The Sewerage & Water Board OF NEW ORLEANS

Addendum No. 1

Your reference is directed to the Invitation to Bid for: **2025-SWB-53 Steel Piping Materials** for the Sewerage and Water Board of New Orleans which proposals are due on **June 25, 2025**, at **11:00 a.m.** CST.

INTRACOASTAL PUMP STATION MACHINERY PLAN

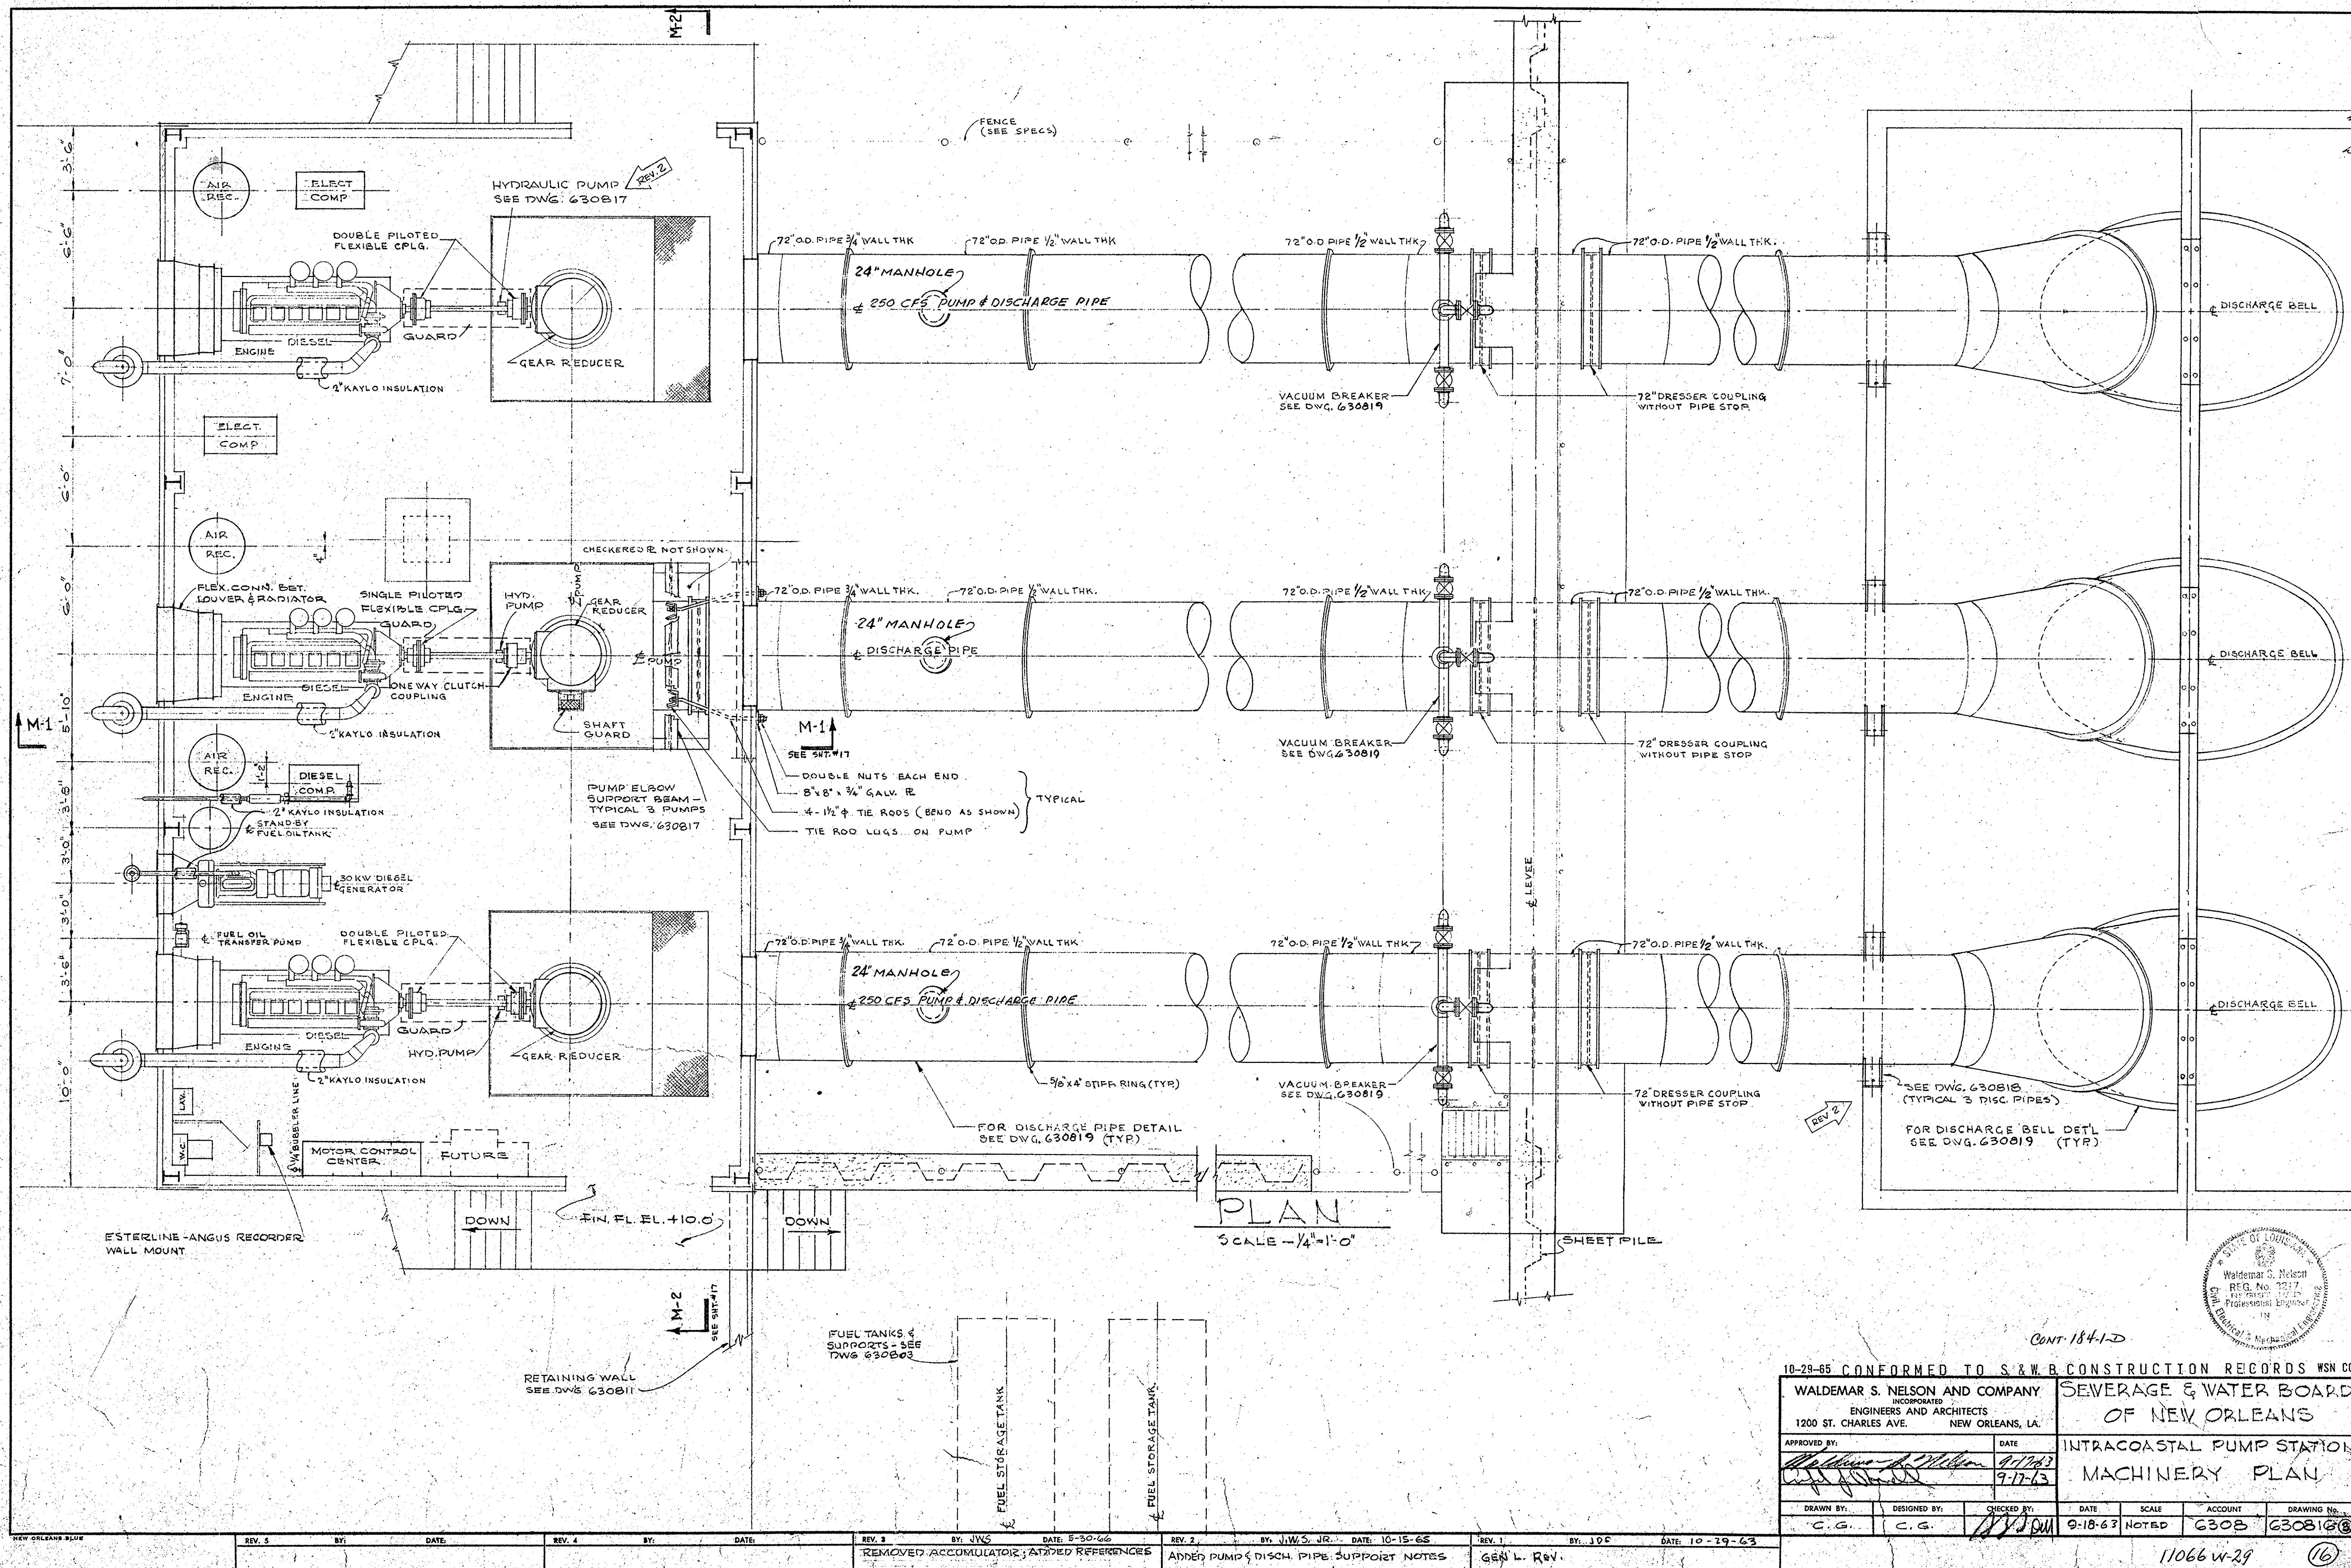
d. *Probably our biggest issue is the quality of the drawings, a number of the notes and dimensions are not legible. Can another clear set be provided, or do you need me to list all the individual issues?*

- *Please see attached.*
